ZEE Systems, Inc.
SERVICE LETTER 58-003-2

1.0 EFFECTIVITY: All SZ58-003-(ALL DASH NOS.) Motors.

2.0 PURPOSE: To provide instructions to check the Z99-845-1 Brush Spring tension and adjust as necessary after installation on the brush holder. Provide a new spring tolerance of 32-52 ounces at ¼ inch pull.

FIG. 1

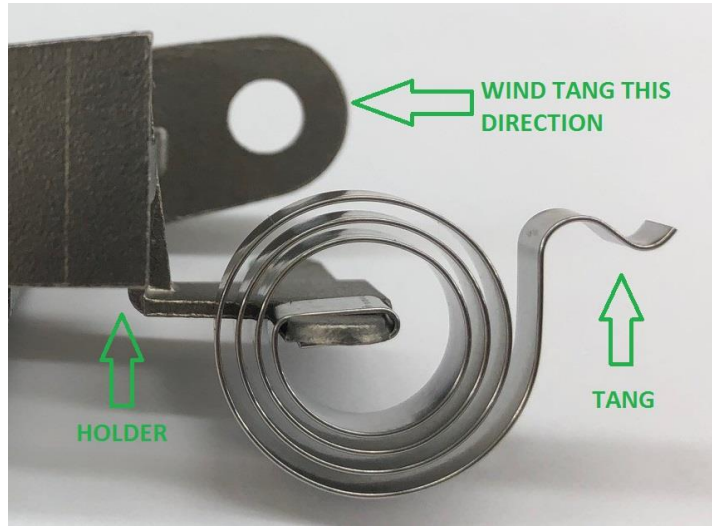
NOTE: The spring tension listed in this Service Letter is different than as listed in the CMM. 32-52 ounces is the new tolerance.

Install the spring on the holder as shown in Fig.1 below. Wind the spring as shown until the tang fits into the holder, FIG. 3. Then check the spring tension. Attach a scale as shown in FIG. 4. Lift the spring from its resting position to ¼ inch off the holder. The spring tension at ¼ inch should be 32-52 ounces.

If the spring tension is too low remove the spring and position 180 degrees clockwise as shown in FIG. 2. Wind the spring as shown until the tang fits into the holder, FIG. 3. Attach a scale as shown in FIG. 4. Then check the spring tension. Lift the spring from its resting position to ¼ inch off the holder. The spring tension at ¼ inch should be 32-52 ounces.

FIG. 4

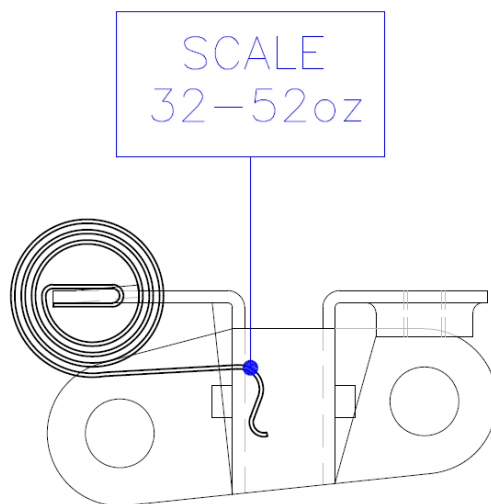
ATTACH SCALE AT •
PULL \triangle 1/4 INCH
